Service Bulletin

Replacement of tailplane mount rivets with bolts.

GA8 all serial numbers up to and including GA8-01-007.

Document: Service Bulletin SB-GA8-2001-01

Figure 1

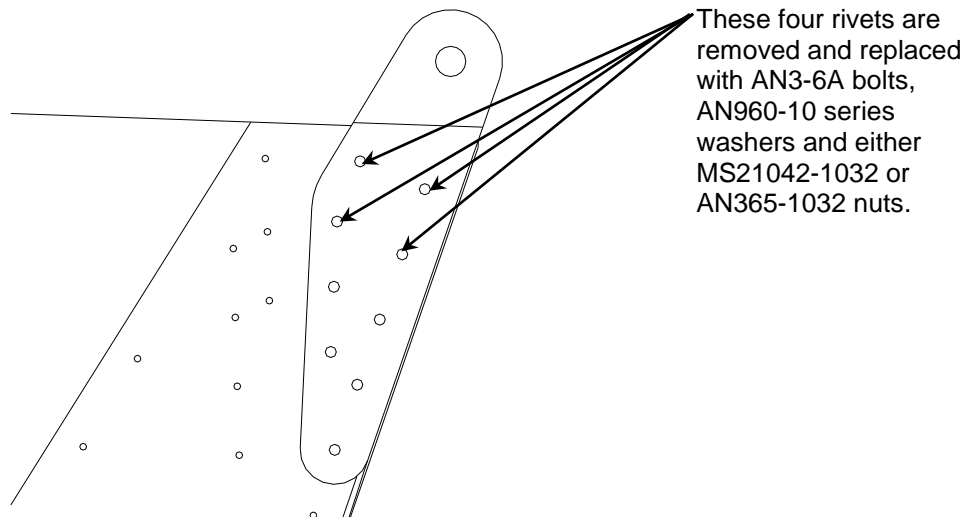
Service experience has shown the rivets which attach the rear tailplane attach brackets to the fuselage may work and fail.

2. Aircraft with more than 200 hours time in service and those required to comply with this action under action 1 must be modified by removing the top four rivets, drilling the holes out to 3/16" \varnothing and installing four AN3-6A bolts with AN960-10 series washers and either MS21042-1032 or AN365-1032 nuts. Ensure the correct thread engagement is achieved by the use of AN960-10 and AN960-10L washers as necessary.

3. Following modification in accordance with action 2 the attachment of the fitting to the fuselage must be inspected at every 100 hourly inspection for any signs of looseness, relaxing of the bolts, further working rivets or general damage. Any defects must be reported to Gippsland Aeronautics before further operation.
